## ANN ARBOR HISTORIC DISTRICT COMMISSION

### Staff Report

**ADDRESS:** 1547 Washtenaw, Application Number HDC16-044

**APPLICATION:** The applicant seeks HDC approval to add eight (8) parking spaces straddling both the 1541 and 1547 Washtenaw properties for staff parking, and restore a planting island near the front of the house. The eight spaces are to be located along the common property line between both properties. The spaces will be completely behind the historic 1547 residence and accessed from the shared driveway. Permeable paving will be used for stormwater management purposes.

N  
1 Proposed - Site Plan  
A-0.1  
10' 20' 40'  
1" = 20'-0"

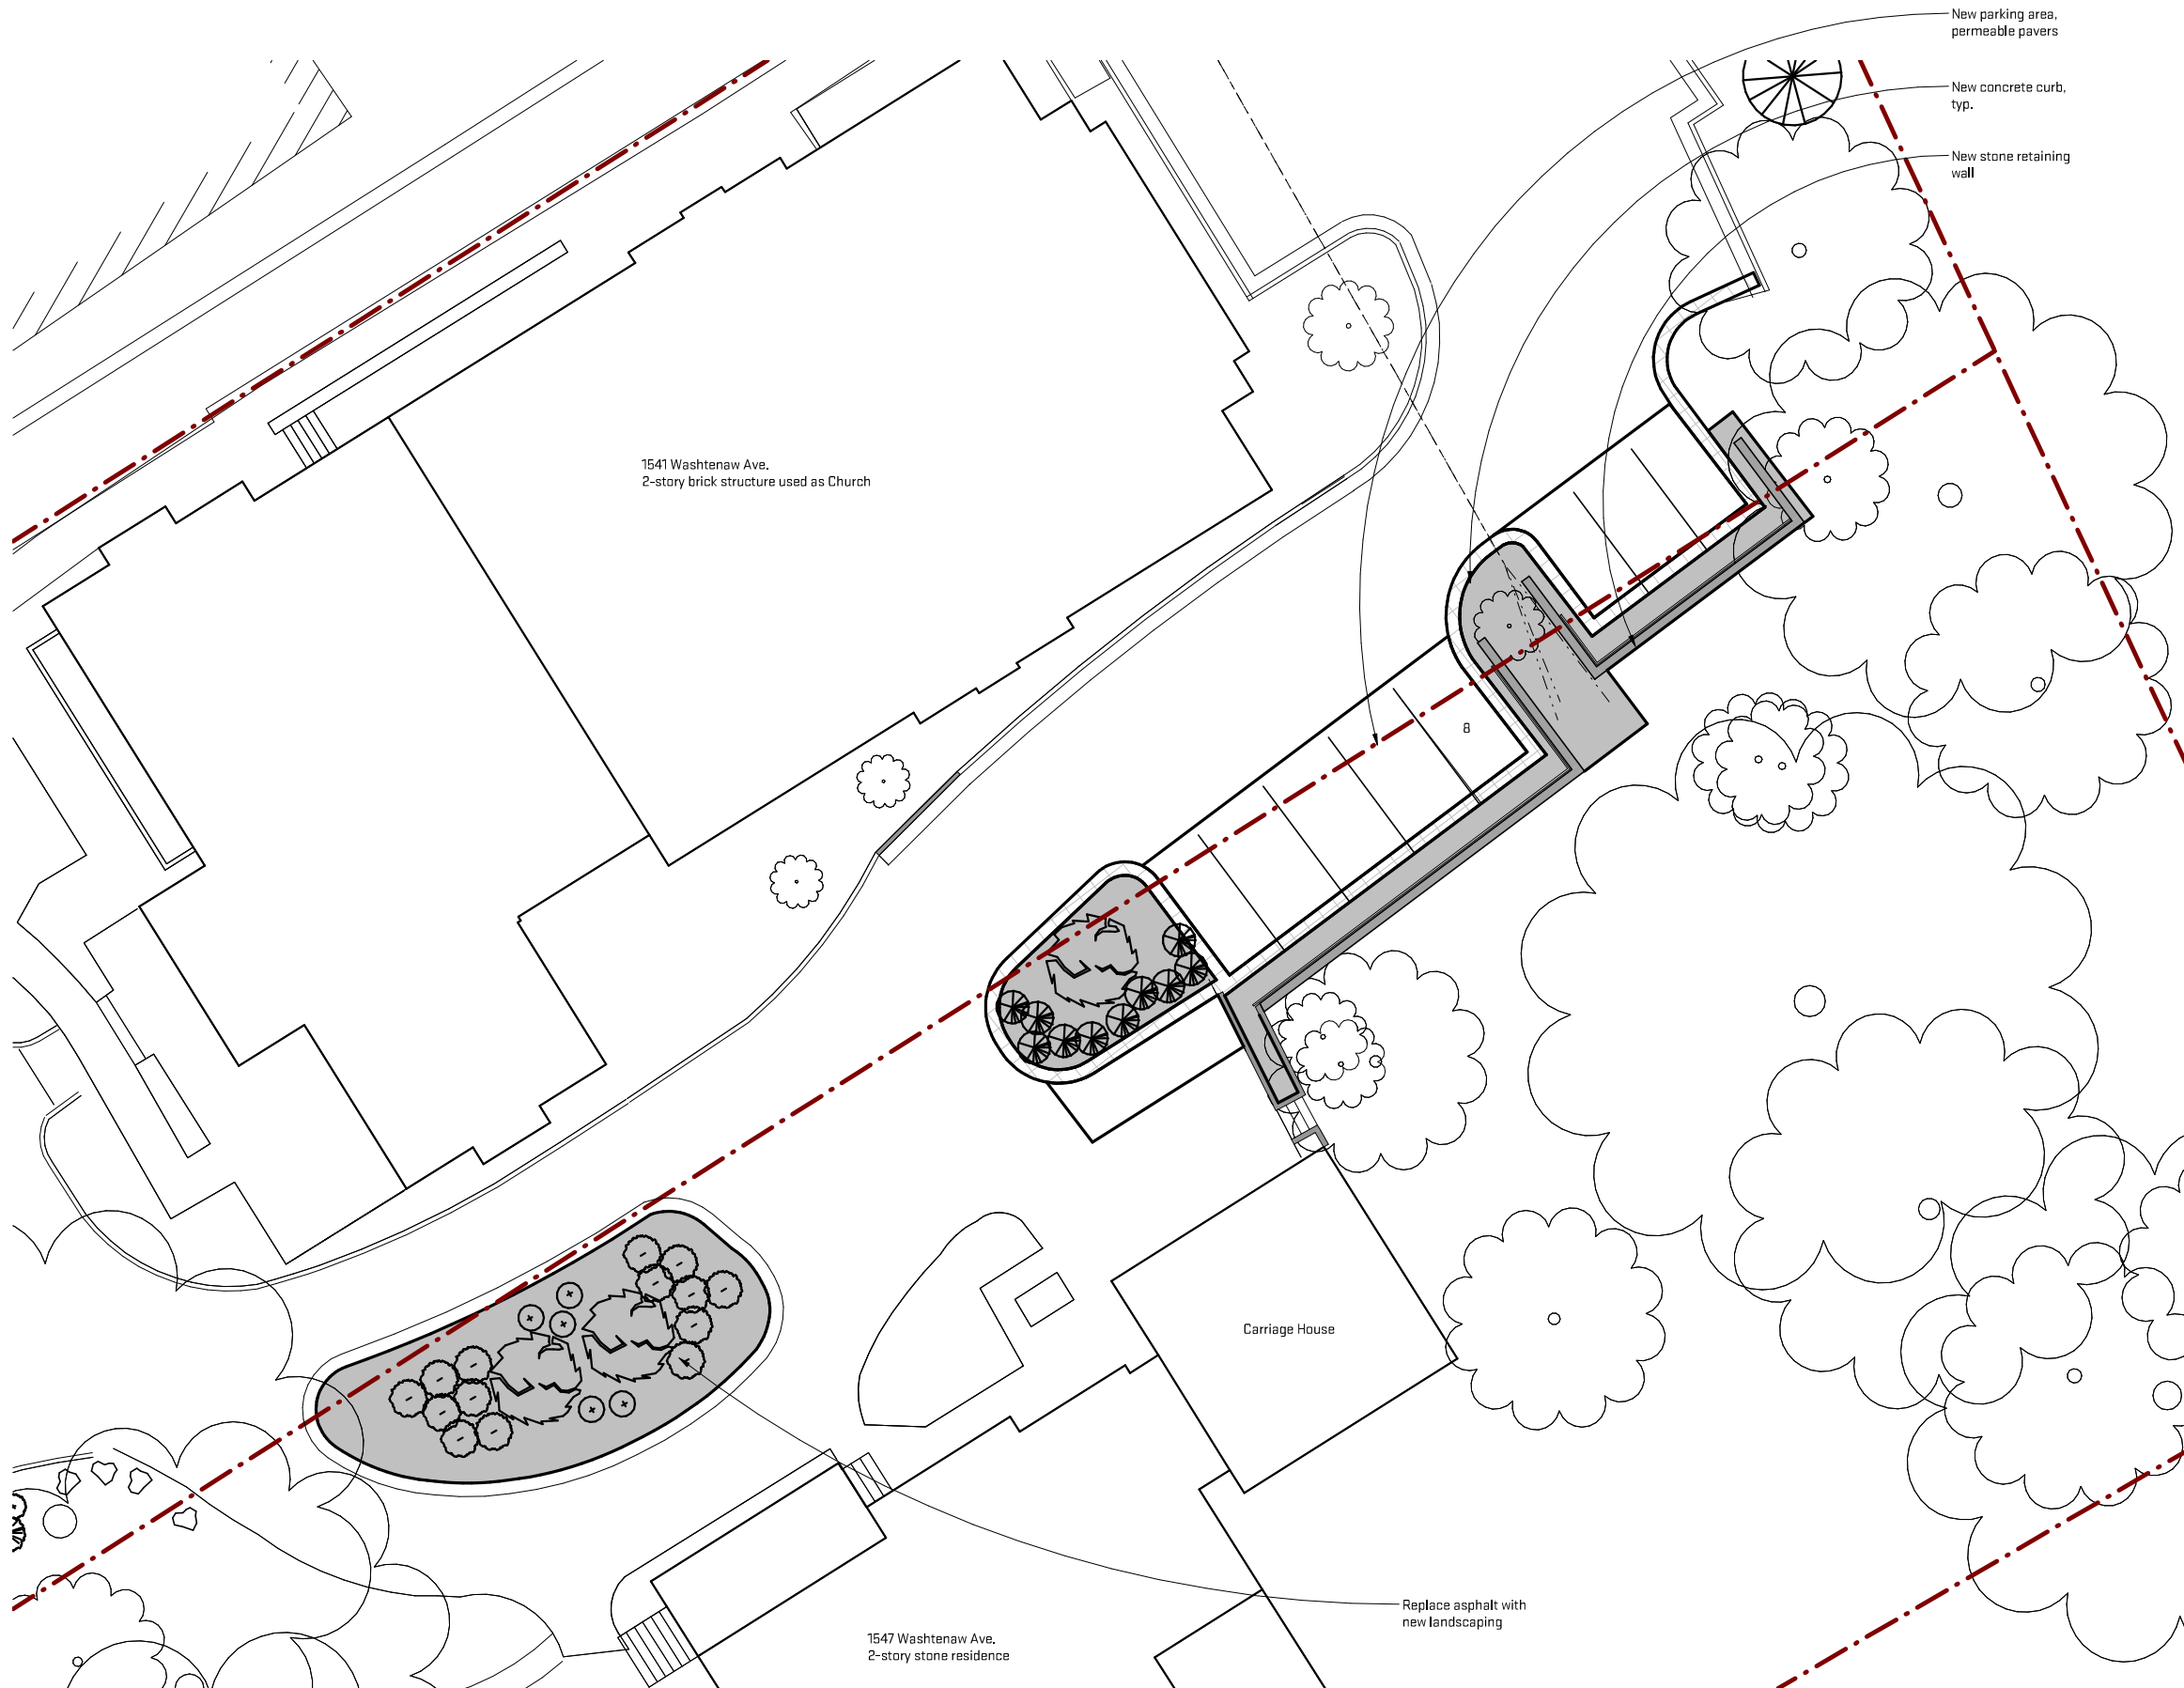
2. The proposed paver parking is behind the historic house and new carriage house, more than 250 feet from the public right-of-way. Approximately nine trees would be removed, none of which are landmark trees. An area of landscaping would be installed next to the parking spaces to help screen them from view, and more importantly, a landscape island in the driveway near the front of the house that was removed and paved over by the previous owners would be reconstructed and planted with trees and bushes.

3. The work is reversible and does not significantly impact the large back yard or the historic character of the historic house.
4. Staff believes the work is sensitive to the structure and neighborhood and generally
